PLANNING COMMISSION MEETING AGENDA REGULAR MEETING

5. PRELIMINARY SITE PLAN REVIEW (File Number SP 979 A) – Proposed Galleria of Troy Phase II, North side of Big Beaver between Wilshire and I-75, Section 21, Currently Zoned BB (Big Beaver) District

SUBJECT: PRELIMINARY SITE PLAN REVIEW (File Number SP 979 A) – Proposed Galleria of Troy Phase II, North side of Big Beaver between Wilshire and I-75, Section 21, Currently Zoned BB (Big Beaver) District

Preliminary Site Plan Review For City of Troy, Michigan

PRELIMINARY SITE PLAN - SOUTH
THE GALLERIA OF TROY - PHASE II
PART OF THE SOUTHWEST 1/4 OF SECTION 21, T. 2N., R. 11E.
CITY OF TROY, OAKLAND COUNTY, MICHIGAN

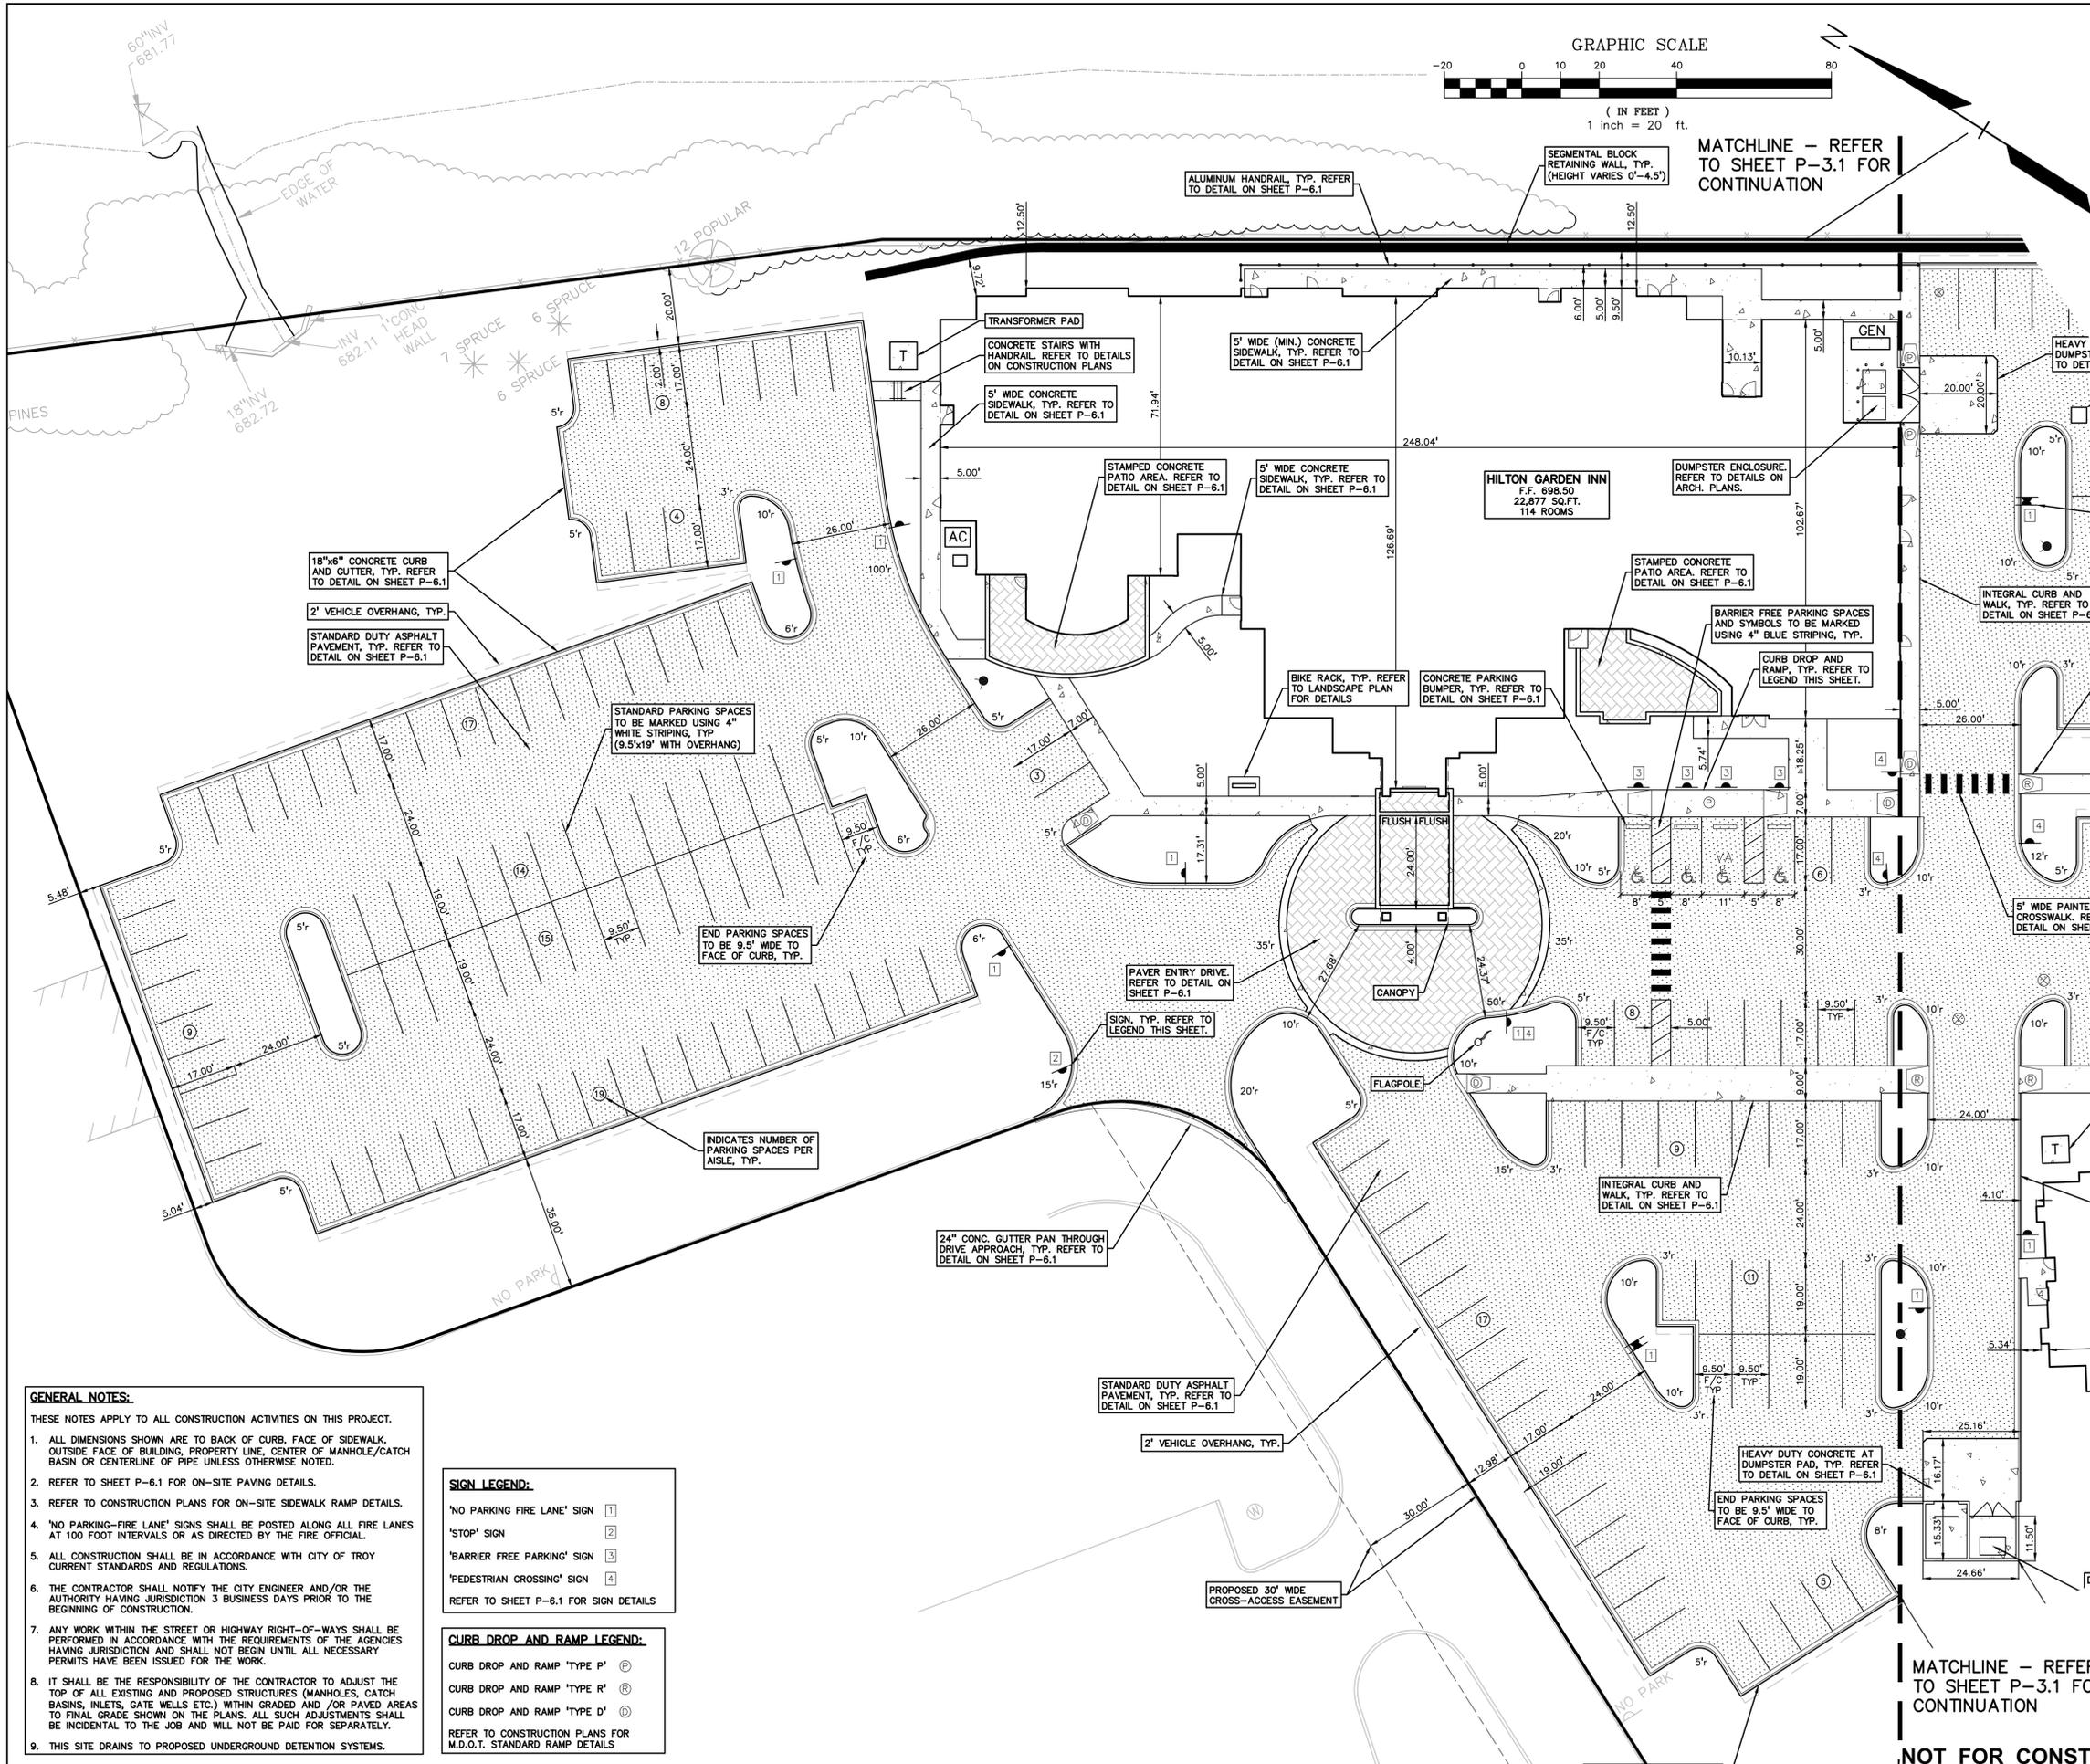
The Hampton Inn is not placed parallel to Wilshire Drive, hence the skewed setback from 10-feet in one corner to 42-feet to the other. The 42-foot setback at the northwest corner of the building does not comply with the Big Beaver Road build-to-line. The Planning Commission may adjust the required build-to-line to a maximum of 30-feet beyond the front property line for projects incorporating a permanent space for an outdoor café and public space. At a minimum the applicant must move the building to within 30-feet of Wilshire Drive. The site plan shows a patio/expanded sidewalk in front of the Hampton Inn along Wilshire Drive. This area appears to lack the pedestrian amenities (benches, pedestrian lighting, landscaping) to make it an engaging and inviting space. The applicant should provide additional details for this area.

Items to be Addressed: 1). Move Hampton Inn within 30-feet of Wilshire Drive and add permanent space for an outdoor café and public space to the satisfaction of the Planning Commission; and 2). Provide open space calculation for Phase II.

The trash enclosure for the Hampton Inn is located along Wilshire Drive. The applicant should move the trash enclosure so that is adjacent to the building to provide better screening from Wilshire Drive. Relocating trash enclosure may require slight reconfiguration of the parking lot.

Items to be Addressed: 1). Relocate Hampton Inn trash enclosure adjacent to the building to provide better screening from Wilshire Drive; and 2). Relocate Hilton Garden Inn trash enclosure to the north side of the building.
